Memo to the Planning Commission

HEARING DATE: SEPTEMBER 28, 2017 Continued from the August 24, 2017 Hearing

Case No.: 2016-001185DRPVAR
Project Address: 711 Corbett Avenue

Discretionary Review Full Analysis

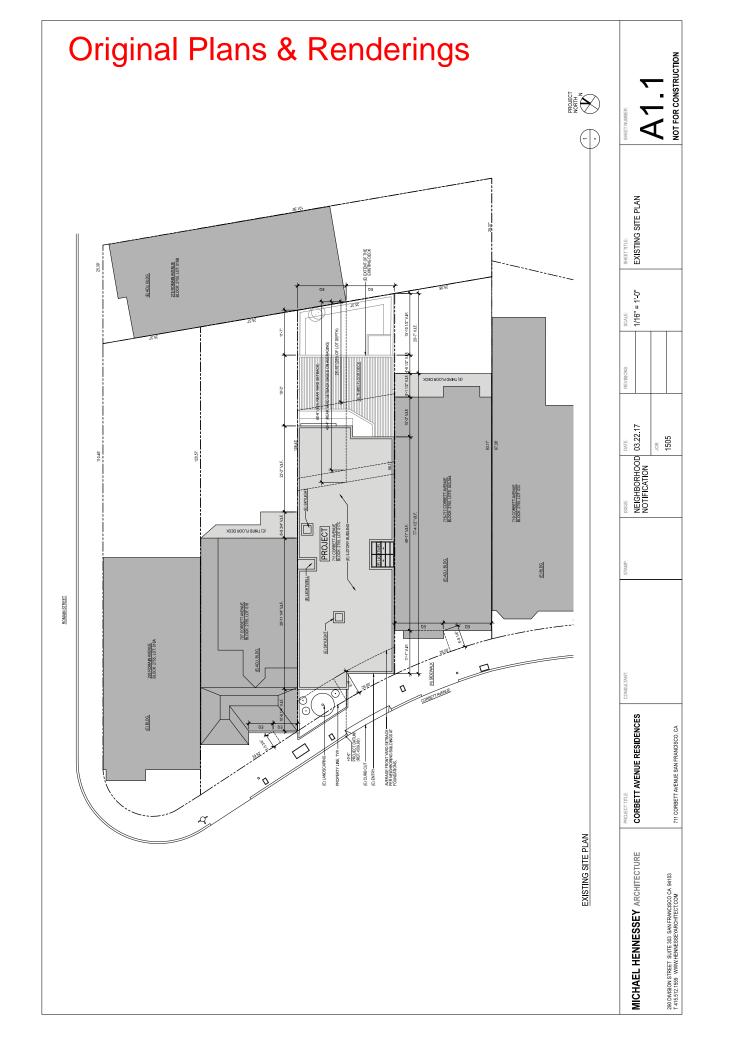
DECK DEPTH REDUCED BY 6'-0" -

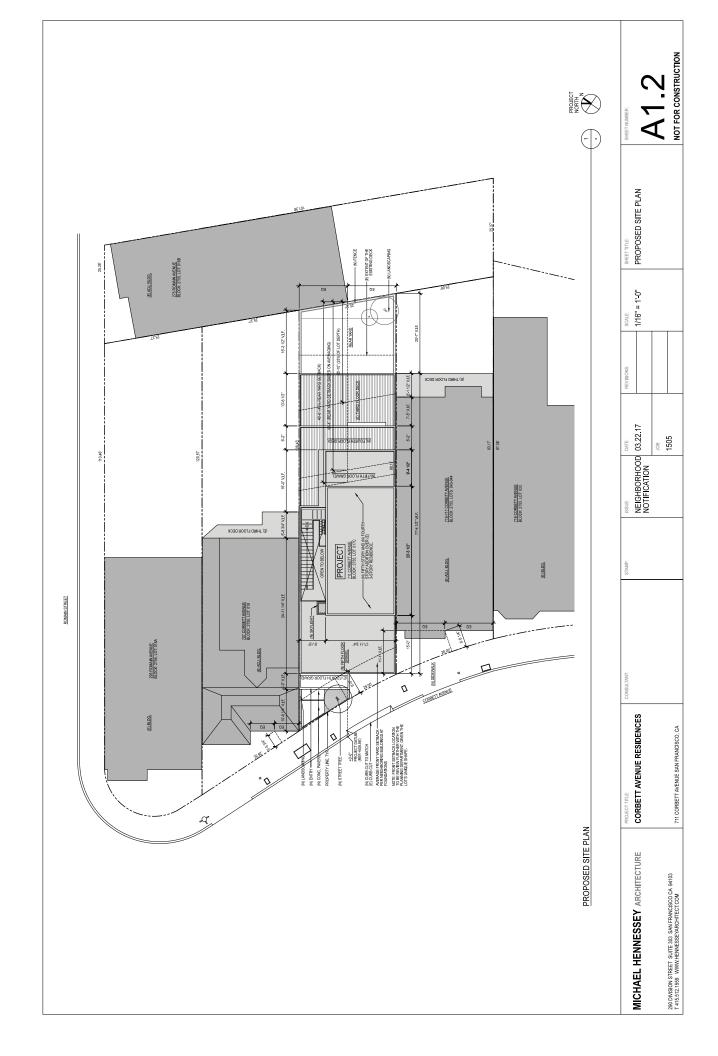
PUSHED REAR WALL OF LOWER UNIT BACK 6'-0" TOWARDS FRONT OF BUILDING

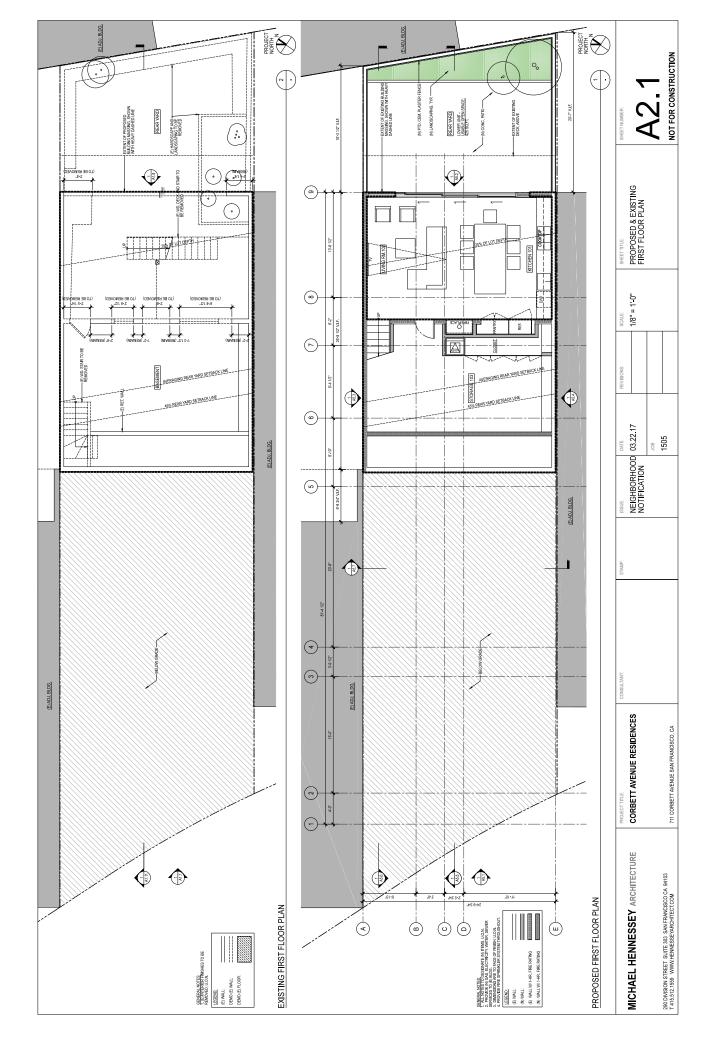
ELIMINATED WINDOWS: 3'-0" HIGH (PROVIDES VISUAL PRIVACY TO DR REQUESTER'S REAR YARD) ——
